From: bjwarchitectural@gmail.com [mailto:bjwarchitectural@gmail.com] **On Behalf Of** Ben Whitby
Sent: 03 May 2013 14:40
To: Hannah Barker
Subject: 136 Greenacres

Proposed Rear Extension
At:
136 Greenacres
Shoreham By Sea
West Sussex
BN43 5XL

Plans & Elevations As Proposed

Drg. No.	Rev'n
05	B

Ground Floor Plan

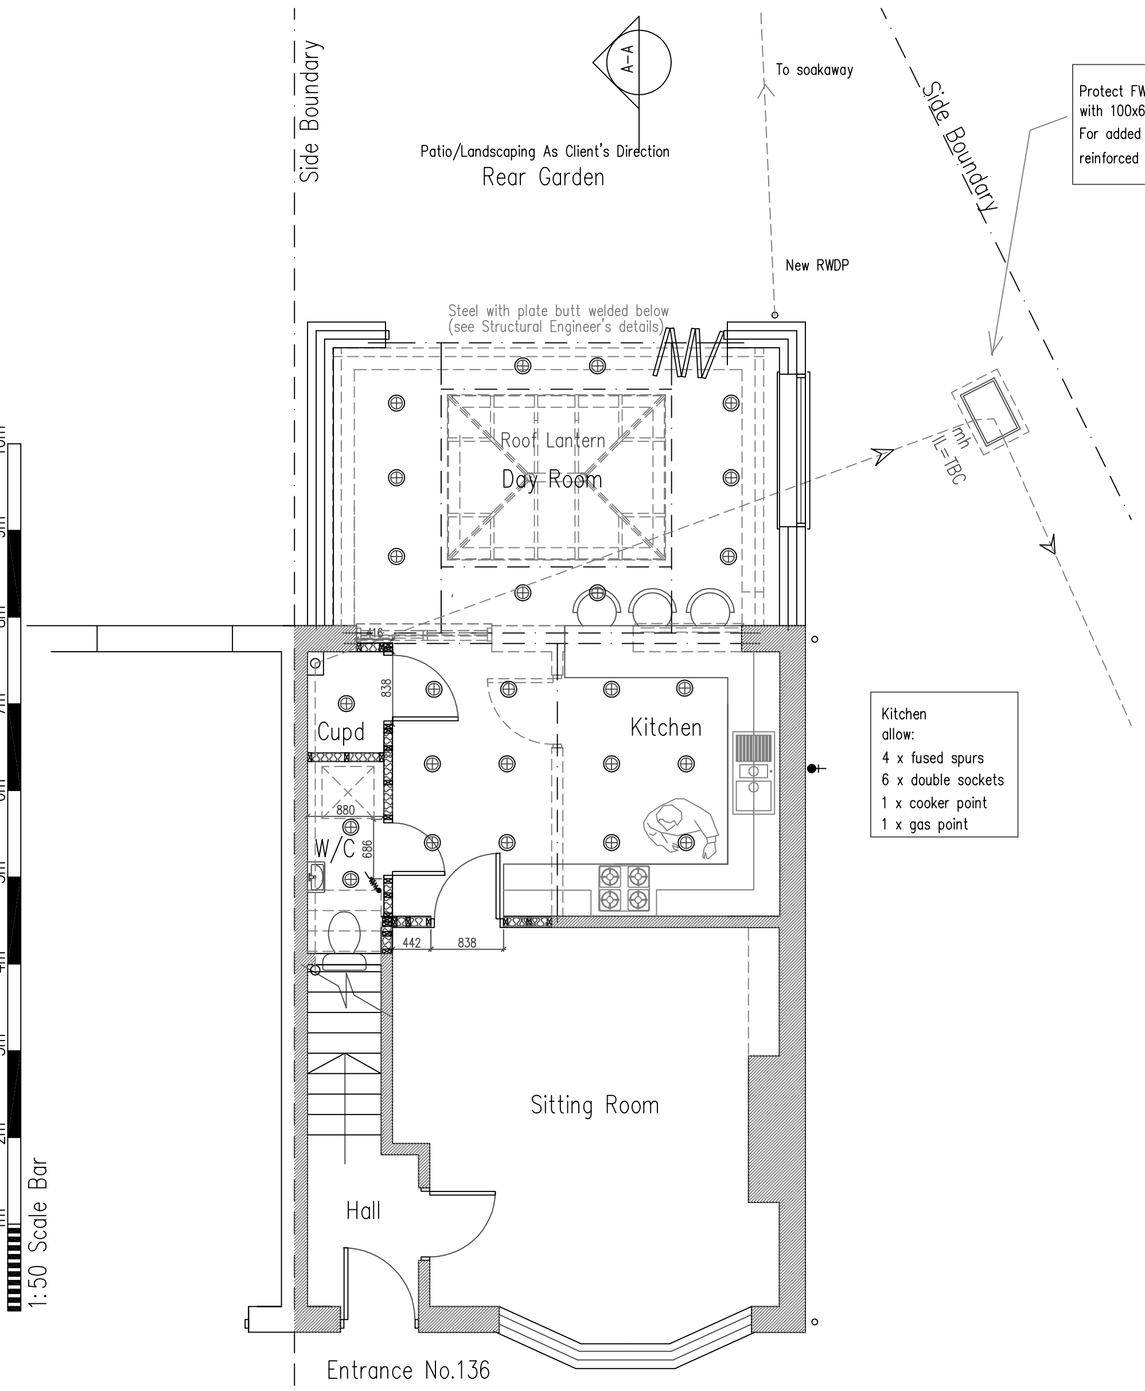
> Hi Ben, I have measured up the hard copy of the plans and the depth of the extension measured externally is 3.8 metres. This needs to be reduced to 3.5 metres in depth measured externally.
>
> Please could I have a revised drawing to meet with this requirement.
>
> Thanks
>
> Hannah

Rev B Attached
